ADDENDUM NO. 4 TO PROJECT NO. 44288

**CONSTRUCTION WORK, HVAC WORK, PLUMBING WORK, ELECTRICAL WORK
REPAIR UNDERGROUND STEAM TUNNELS
WILLARD DRUG TREATMENT CENTER
7116 COUNTY ROUTE 132
WILLARD, NY**

March 14, 2013

DRAWING NUMBER:
S-521

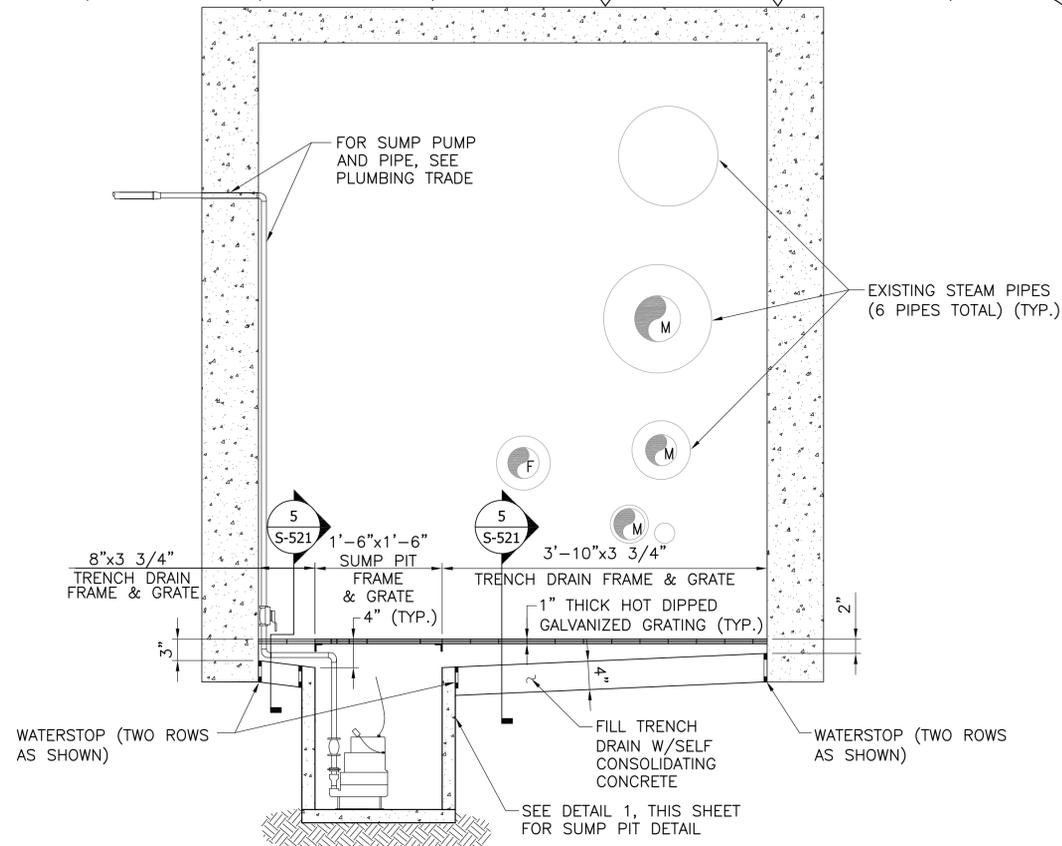
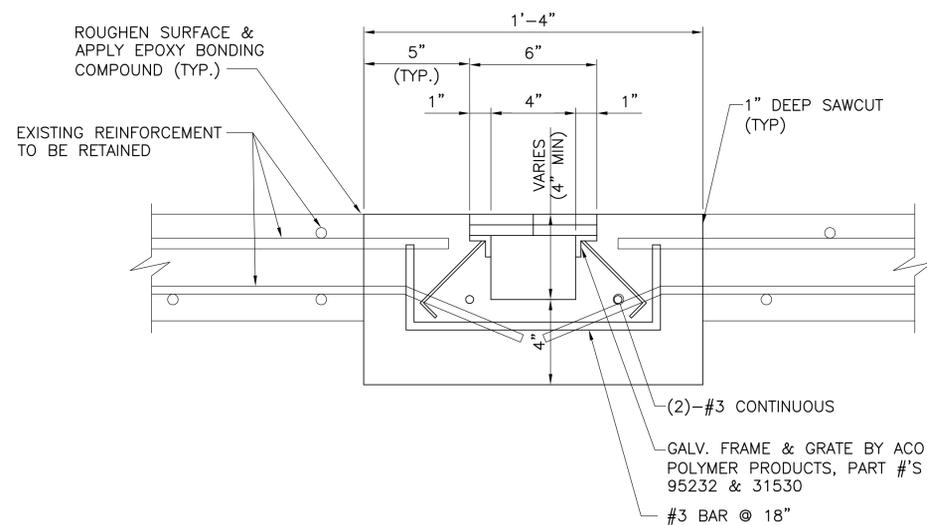
REVISED DRAWING
3/13/2013

SHEET TITLE: PIPE SADDLE DETAILS

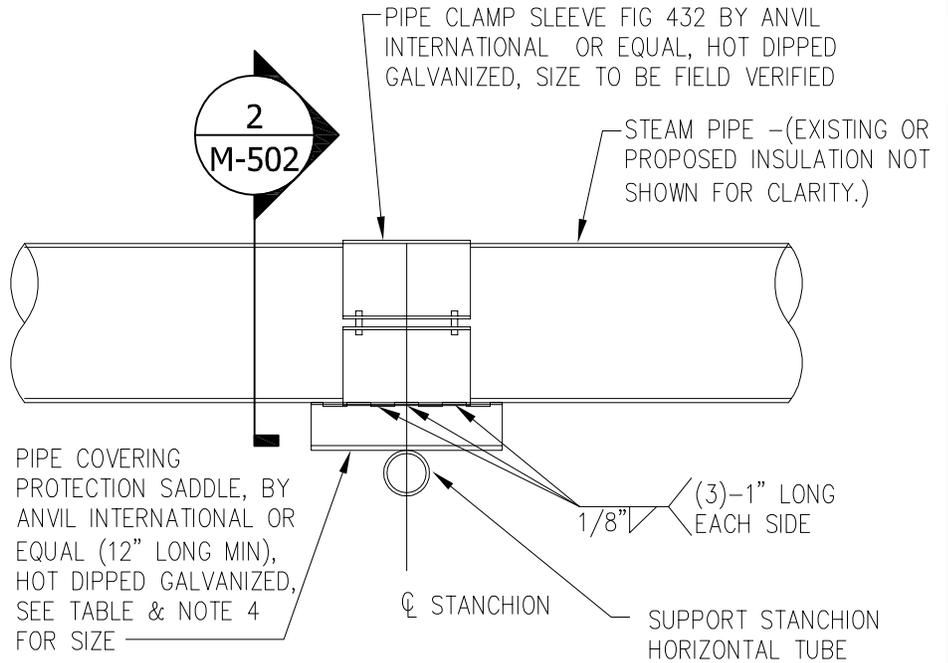
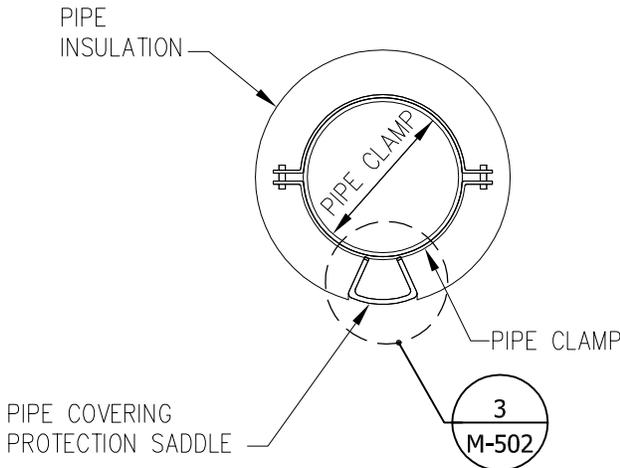
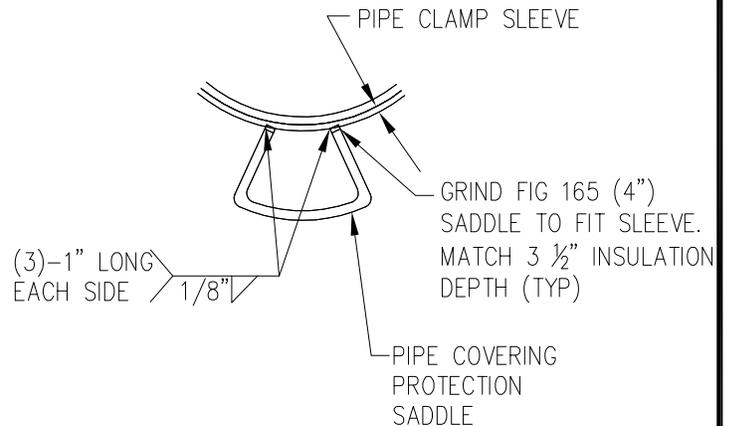
2. DRAWING M-102, noted "REVISED DRAWING 02/22/2013": Revise all occurrences of 5" to 6" (32 PSI OPERATING PRESSURE).
3. DRAWING M-102, noted "REVISED DRAWING 02/22/2013": Add the following leadered note to the two steam line tie-in points:
"PROVIDE GATE VALVES AT CONNECTION POINTS FOR BOTH STEAM AND CONDENSATE"
4. DRAWING M-501, noted "REVISED DRAWING 02/22/2013", Detail 5: Replace Detail 5 with the accompanying drawing M-503, dated 3/13/2013.
5. DRAWING M-501, noted "REVISED DRAWING 02/22/2013", Detail 6: Revise two occurrences of 5" to read 6".
6. DRAWING M-501, noted "REVISED DRAWING 02/22/2013", Detail 9: Remove Detail 9 from the drawing.
7. Add the accompanying DRAWING M-502, dated 3/13/2013, to the HVAC DRAWINGS.
